Technical Service Bulletin

96 Lane change assist: side assist and exit warning system: unavailable. Sensor view restricted (DTC C12AA00)

96 24 99 2073683/2 June 21, 2024. Supersedes Technical Service Bulletin Group 91 number 24-01 dated April 16, 2024 for reasons listed below.

Model(s)	Year	VIN Range	Vehicle-Specific Equipment
RS 6 Avant	2021 - 2025	All	Not Applicable

Figure 1: Illustration showing positioning of holes for spreader rivets.

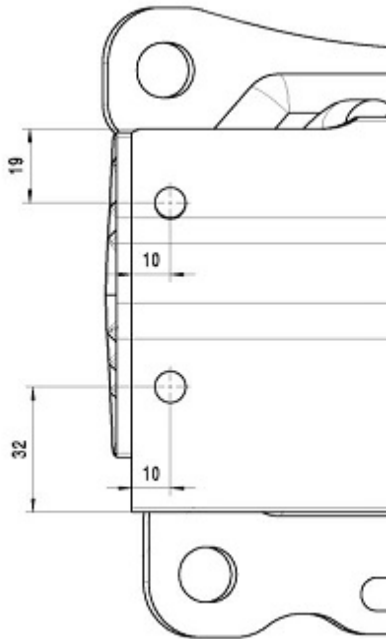
To secure the covers, two holes (8 mm diameter) must be drilled on each side (left and right) of the bumper cover, as shown in the image below:

Figure 2: Cover mounted on bumper carrier (left side).

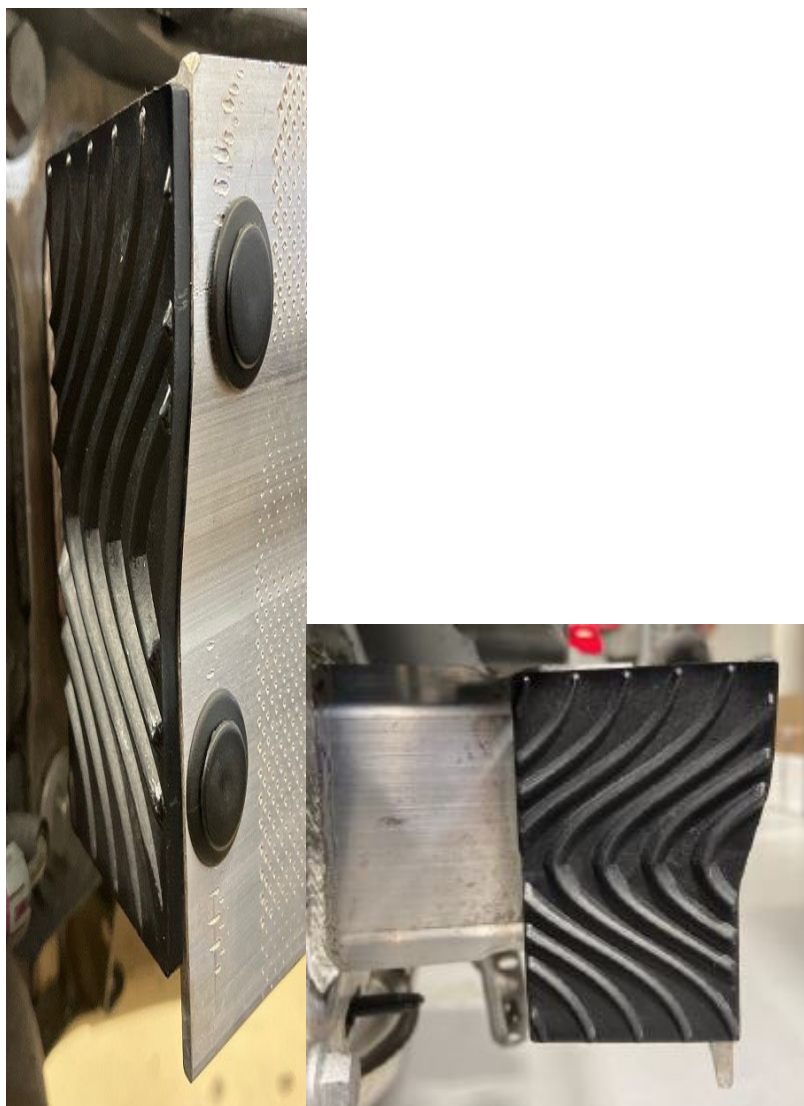
Re Cover the holes and openings on both sides of the bumper carrier. To do so, please use the following covers:

- 4K0 807 245 / 4K0 807 246

Please use the following spreader rivet to secure the covers on the bumper carrier:

- N 905 584 01 (2x per side)
